UNITED STATES PATENT AND TRADEMARK OFFICE

Office Action Summary

10/083,079

SCHUTZ, DOMINIK

Fig.1

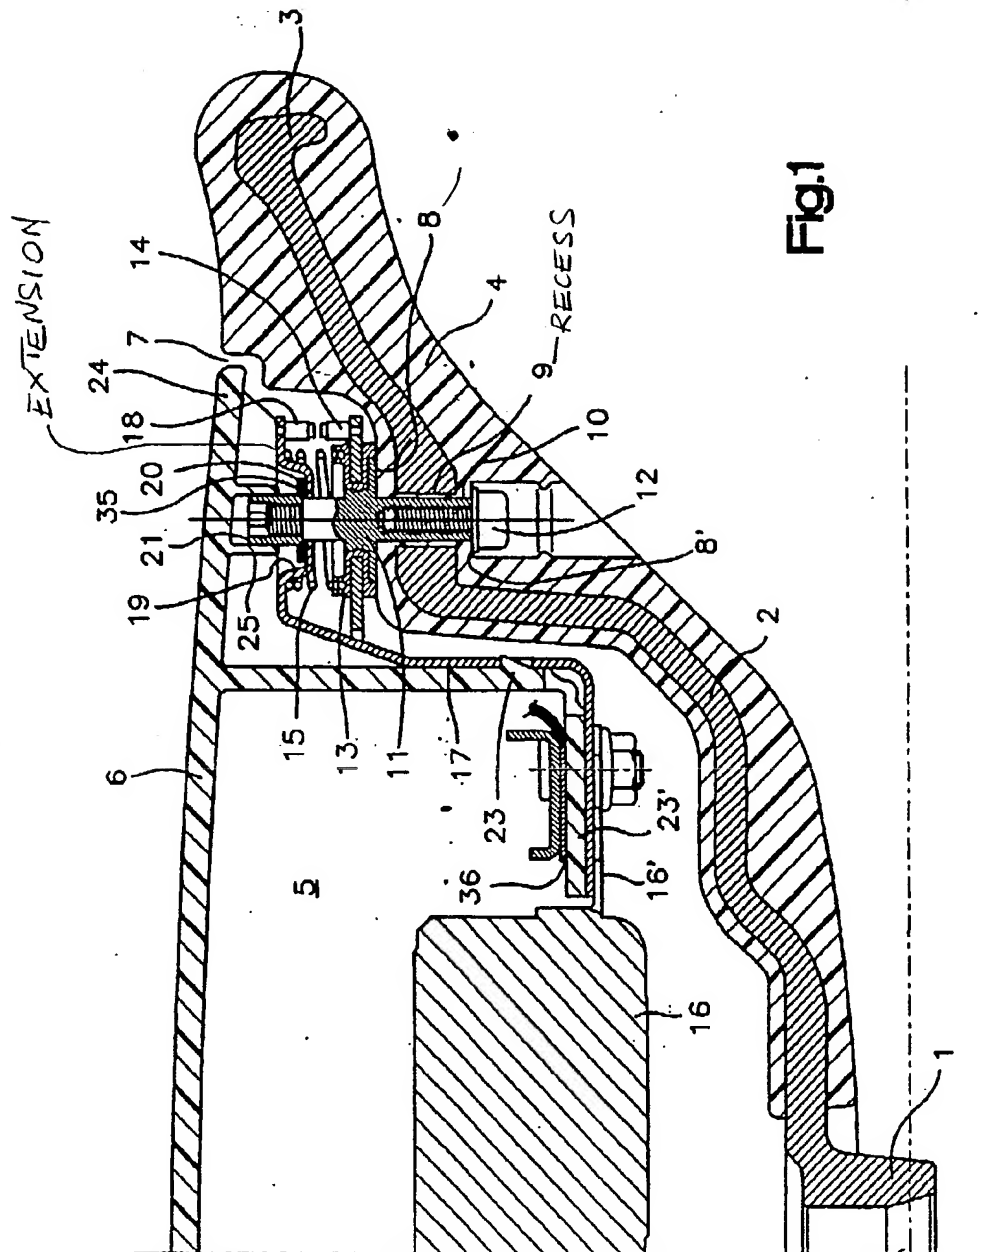
a covering cap 6 having an edge 24 (Fig. 1), said covering cap 6 for actuation of a horn (see lines 29-41, column 1 of Pat.'012) being mounted so as to be *displaceable* in an axial direction (see lines 10-20, column 4 of Pat.'012), said foam casing 4 of said skeleton 1-3 adjoining said edge 24 of said covering cap 6;

Regarding claim 3, said gas bag module 5 has a cup-shaped receiving housing 17 which is open toward said covering cap 6 and adapted to receive a gas bag 16, an edge of said receiving housing 17 having extensions 17 (Fig. 2, see Attachment 1) projecting laterally outwards and toward said edge 24 of said covering cap 6, said guides 10 or 10, 26 being provided on said extensions 17.

Fig.3

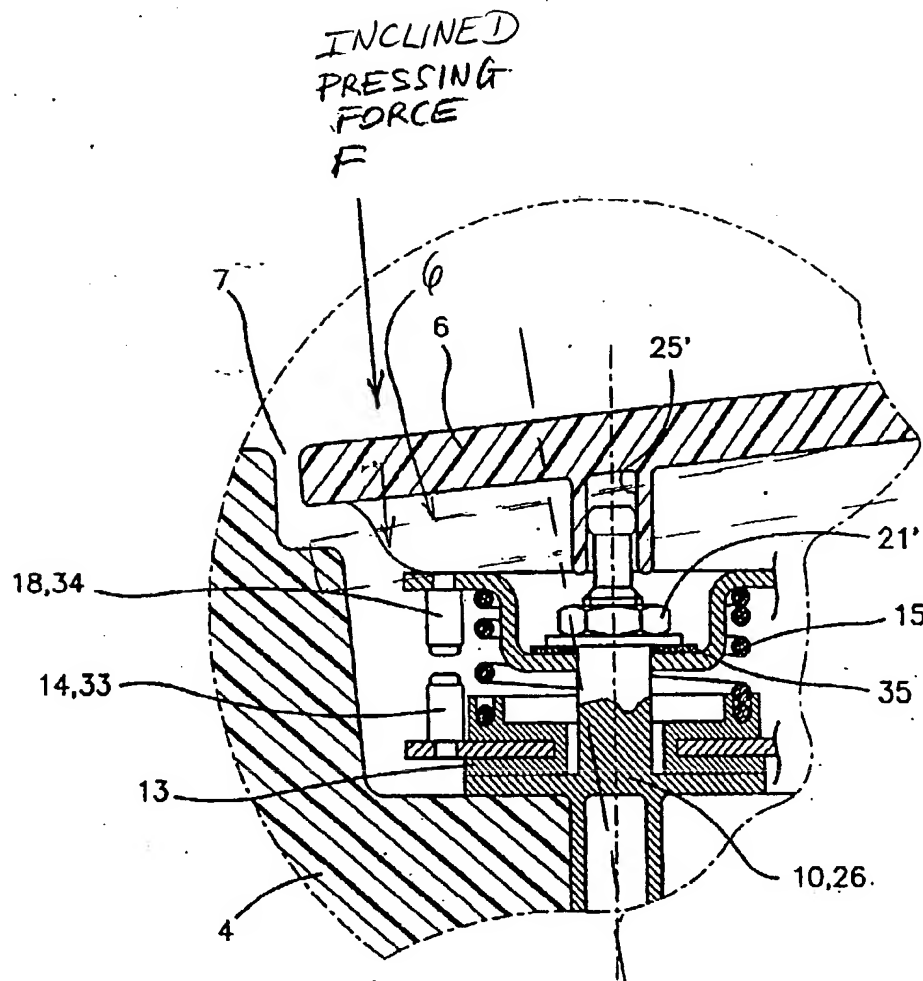
Regarding claim 9, said guides 10 or 10, 26 are received in said covering cap 6 so as to inherently have no lateral play (Figs. 1-3).

1/5

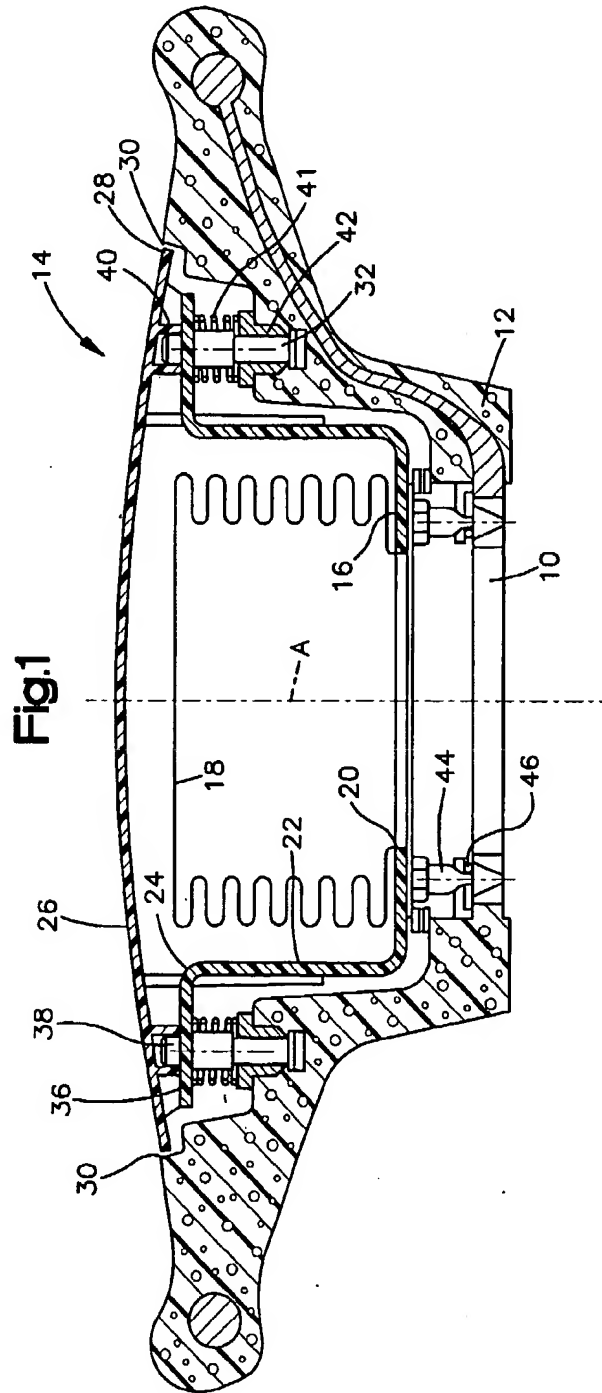
4. The drawings are objected to because Fig. 1 should have referential numerals 62 and 64 to designate the electrical contact in claim 1. Corrected drawing sheet set forth in the information on how to effect drawing changes above are required in reply to the Office action to avoid abandonment of the application.

The original Fig. 1 shows that the element 12 is made of sand or the like in accordance with the drawing symbols for draftspersons in MPEP 608.02. Similarly, claim 5 calls for the plastic housing 16, however, the original Figs. 1-5 do not show the drawing symbol for plastic in MPEP 608.02.

6. The original disclosure is objected to because of the following informalities: the specification and the claims are inconsistent with the original drawings. For example, claim 1 claims the foam casing 12, however, the original Fig. 1 shows that the element 12 is made of sand or the like in accordance with the drawing symbols for draftspersons in MPEP 608.02.

Disapproved

Fig.2

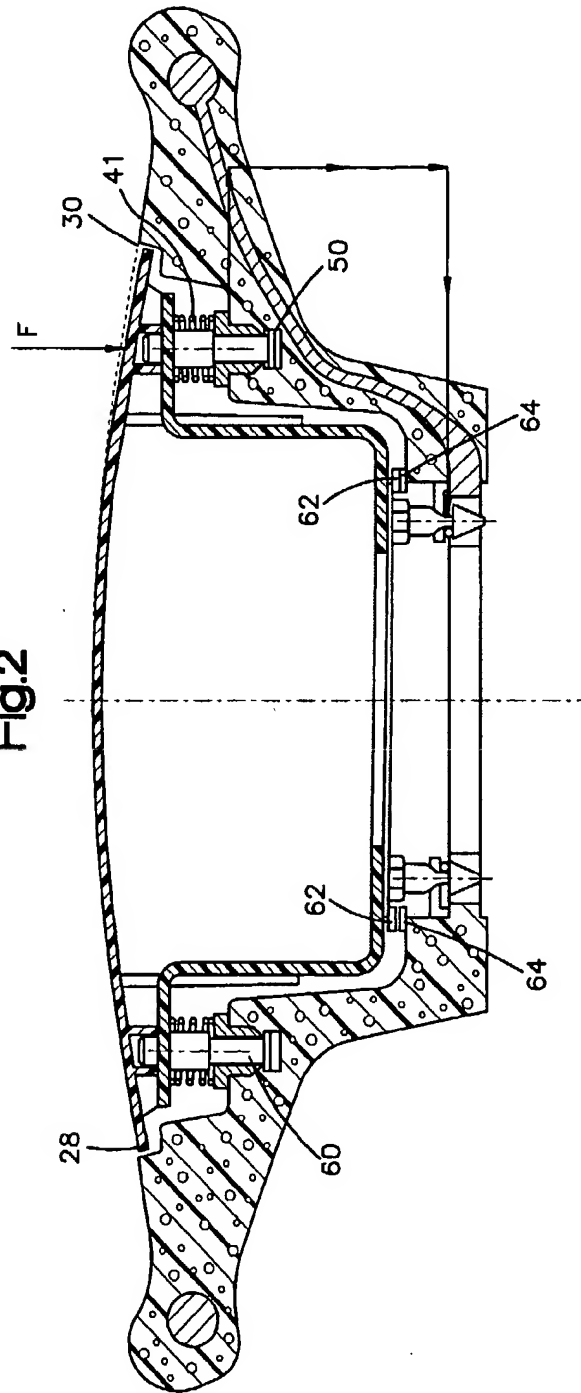
Disapproved
VL
6/7/04

Fig. 4a

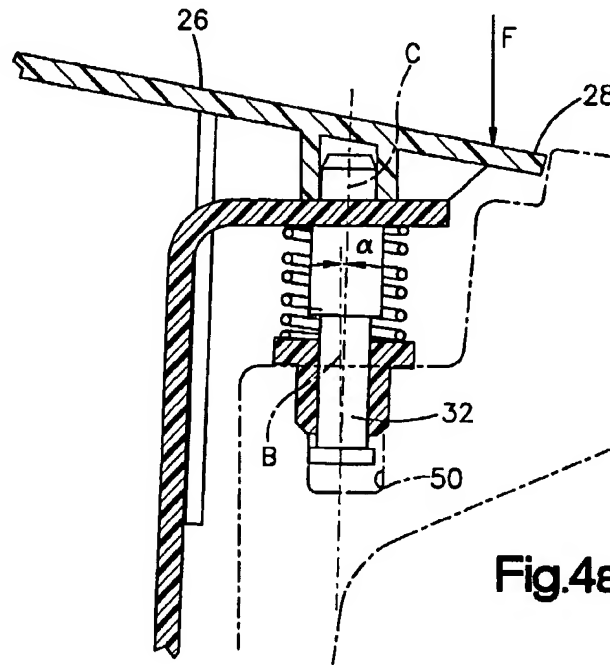
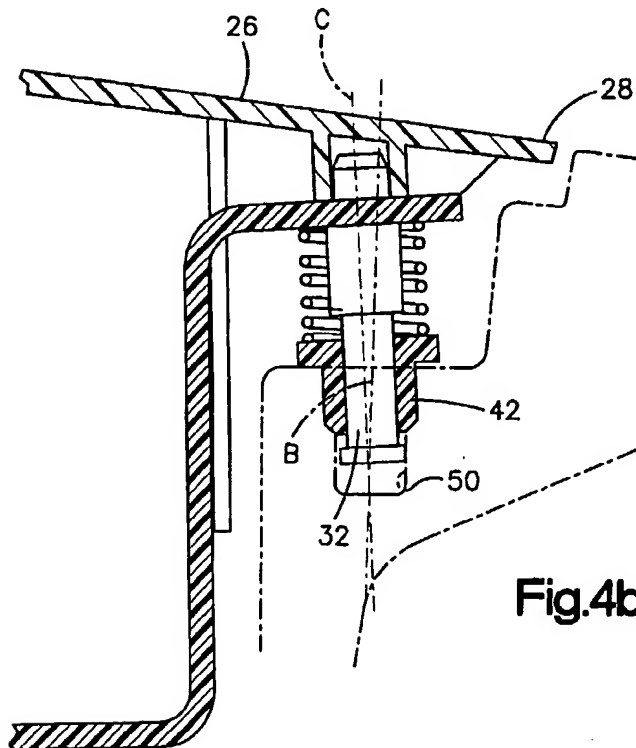
edge of Bohn's casing 6, Bohn's flange 11 and washer 13 do not prevent the tilting of the studs 10 in the same manner shown in Applicant's Figs. 4a and 4b. *In re Merck & Co., Inc.*, 231 USPQ 375 (CAFC 1986) and *In re King*, 231 USPQ 136 (CAFC 1986).

Disapproved

Fig.5

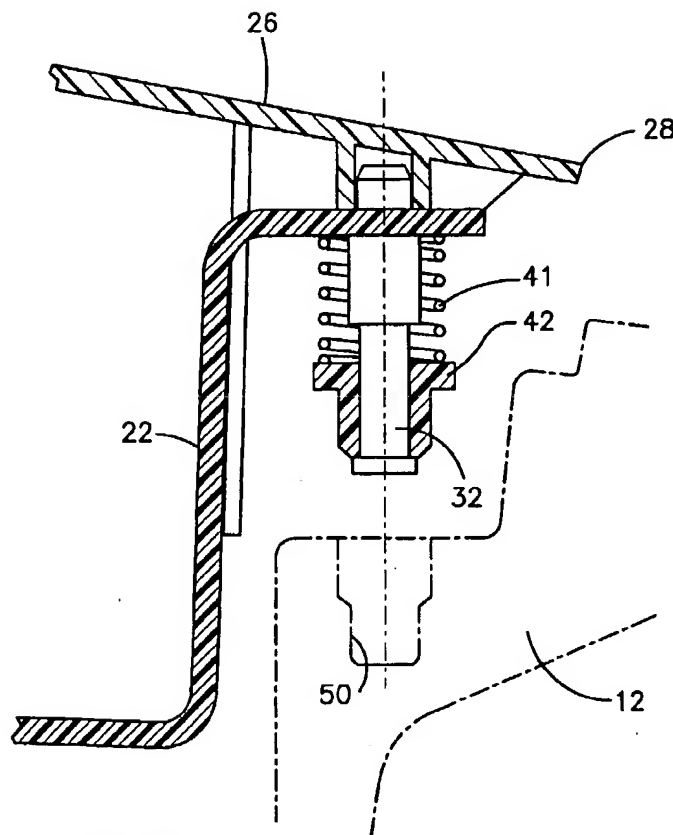
On the other hand, Bohn's flange 11 and washer 13 are similar to the flange of Applicant's bearing bushing 42 in Fig. 5 (see Attachment 2), *a fortiori*, they are expected to behave similarly. In other words, when one applies a sufficient inclined force at the region of the

Disapproved
UL
6/7/04
